SERIAL: NLS-84-107

Brunswick Steam Electric Plant
Proposed Technical Specification Pages - Unit 1

Summary List of Revisions
Brunswick Unit 1

Brunswick Steam Electric Plant
Proposed Technical Specification Pages - Unit 2

Figure 4.7.5-1

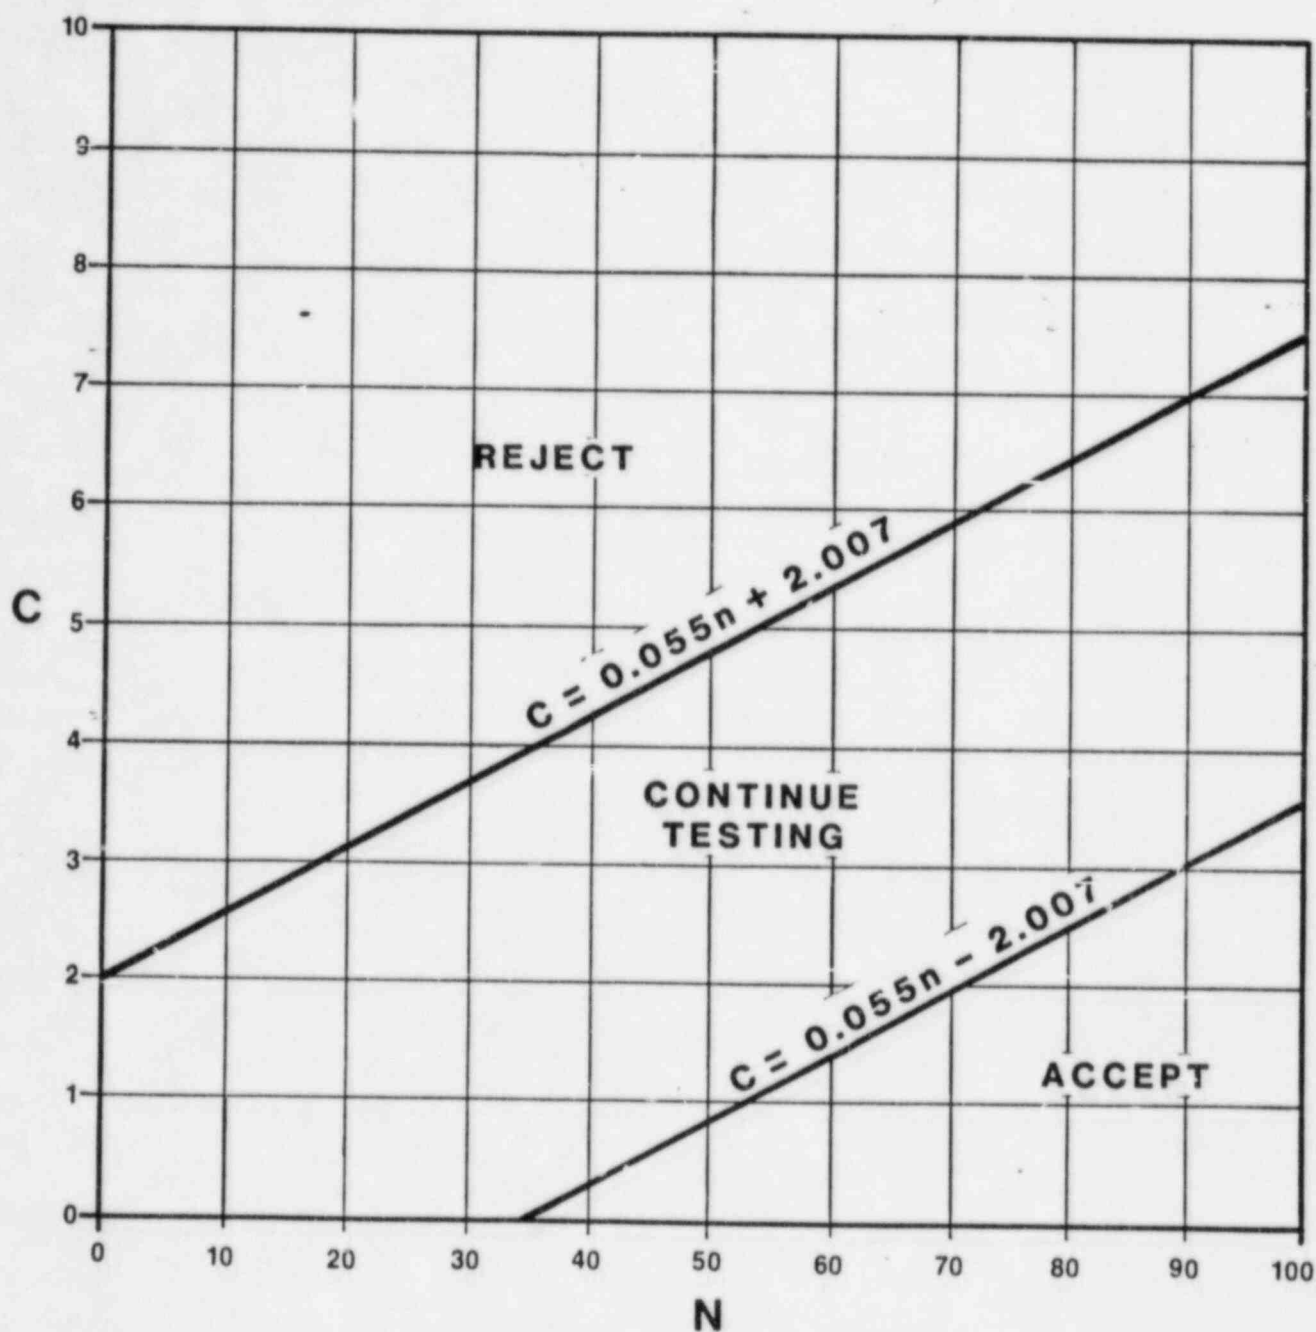
- 2) A representative sample of each type of snubber shall be functionally tested in accordance with Figure 4.7.5-1. "C" is the total number of snubbers of a type found not meeting the acceptance requirements of Specification 4.7.5.f. The cumulative number of snubbers of a type tested is denoted by "N." At the end of each day's testing, the new values of "N" and "C" (previous day's total plus current day's increments) shall be plotted on Figure 4.7.5-1. If at any time the point plotted falls in the "Reject" region all snubbers of that type shall be functionally tested. If at any time the point plotted falls in the "Accept" region, testing of snubbers of that type may be terminated. When the point plotted lies in the "Continue Testing" region, additional snubbers of that type shall be tested until the point falls in the "Accept" region or the "Reject" region, or all the snubbers of that type have been tested. Testing equipment failure during functional testing may invalidate that day's testing and allow that day's testing to resume anew at a later time, providing all snubbers tested with the failed equipment during a day of equipment failure are retested.

If any snubber selected for functional testing either fails to lock up or fails to move, i.e., frozen-in-place, the cause will be evaluated and if caused by manufacturer or design deficiency all snubbers of the same type subject to the same defect shall be functionally tested. This testing requirement shall be independent of the requirements stated in Specification 4.7.5.e for snubbers not meeting the functional test acceptance criteria.

Figure 4.7.5-1

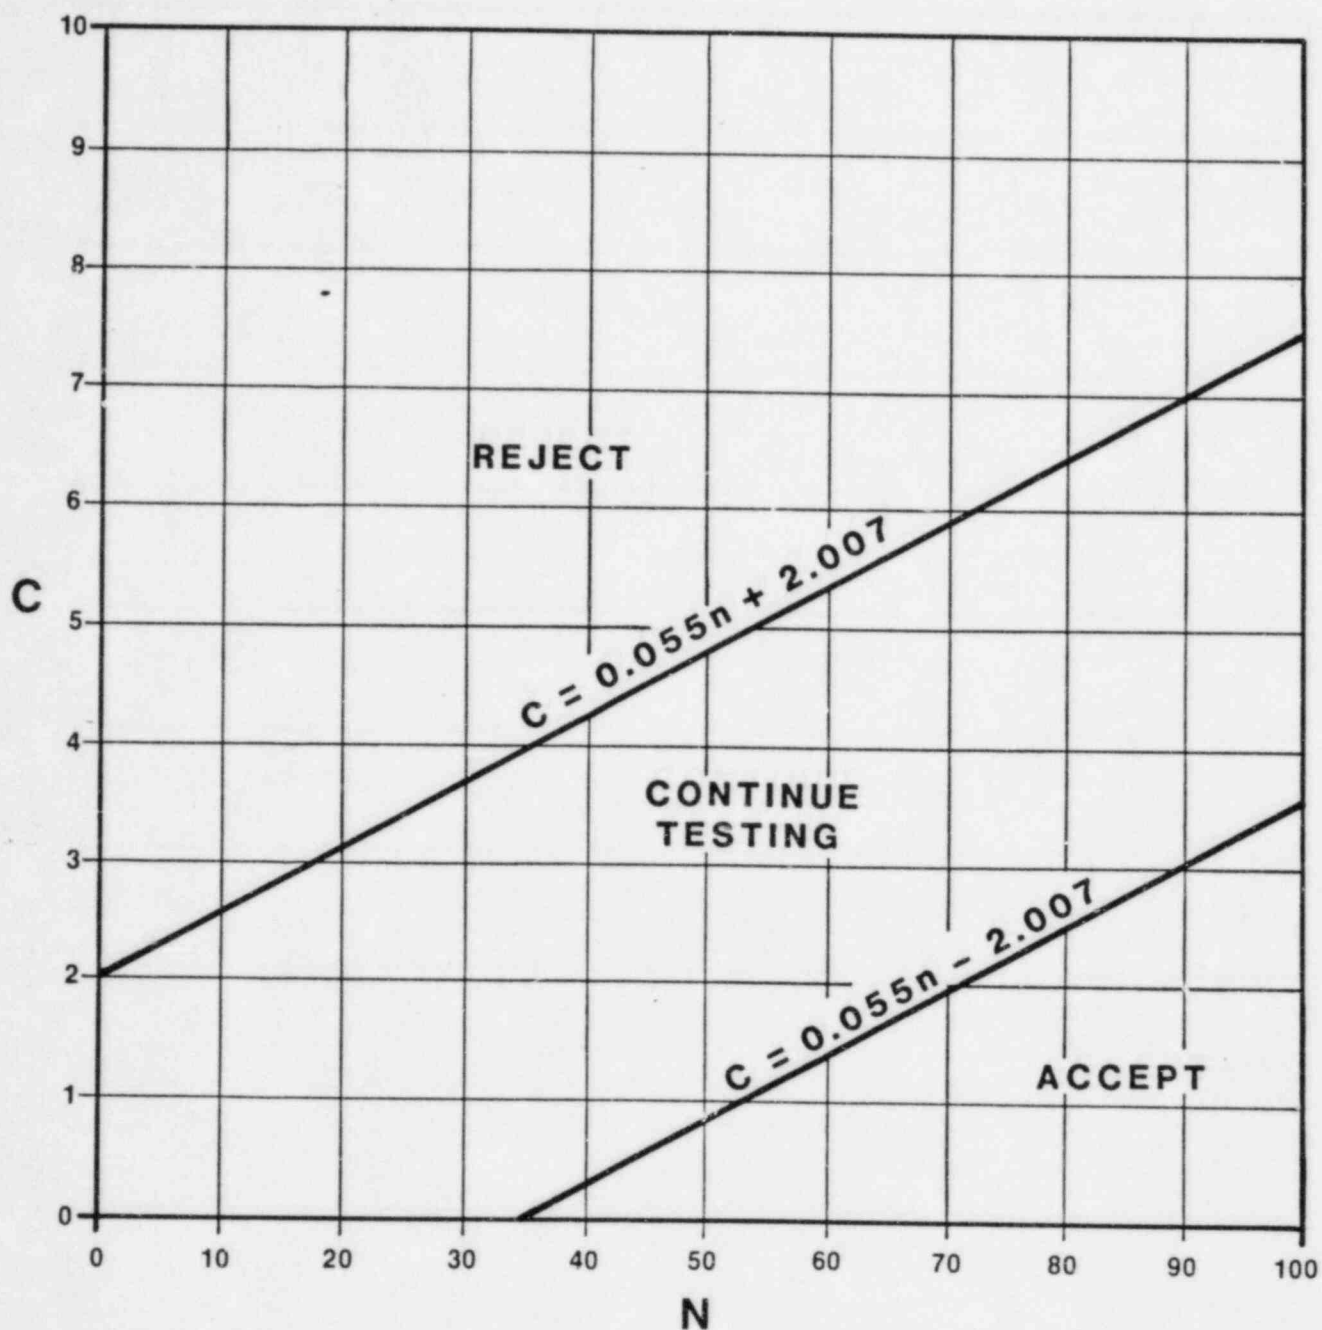
- 2) A representative sample of each type of snubber shall be functionally tested in accordance with Figure 4.7.5-1. "C" is the total number of snubbers of a type found not meeting the acceptance requirements of Specification 4.7.5.f. The cumulative number of snubbers of a type tested is denoted by "N." At the end of each day's testing, the new values of "N" and "C" (previous day's total plus current day's increments) shall be plotted on Figure 4.7.5-1. If at any time the point plotted falls in the "Reject" region all snubbers of that type shall be functionally tested. If at any time the point plotted falls in the "Accept" region, testing of snubbers of that type may be terminated. When the point plotted lies in the "Continue Testing" region, additional snubbers of that type shall be tested until the point falls in the "Accept" region or the "Reject" region, or all the snubbers of that type have been tested. Testing equipment failure during functional testing may invalidate that day's testing and allow that day's testing to resume anew at a later time, providing all snubbers tested with the failed equipment during a day of equipment failure are retested.

If any snubber selected for functional testing either fails to lock up or fails to move, i.e., frozen-in-place, the cause will be evaluated and if caused by manufacturer or design deficiency all snubbers of the same type subject to the same defect shall be functionally tested. This testing requirement shall be independent of the requirements stated in Specification 4.7.5.e for snubbers not meeting the functional test acceptance criteria.
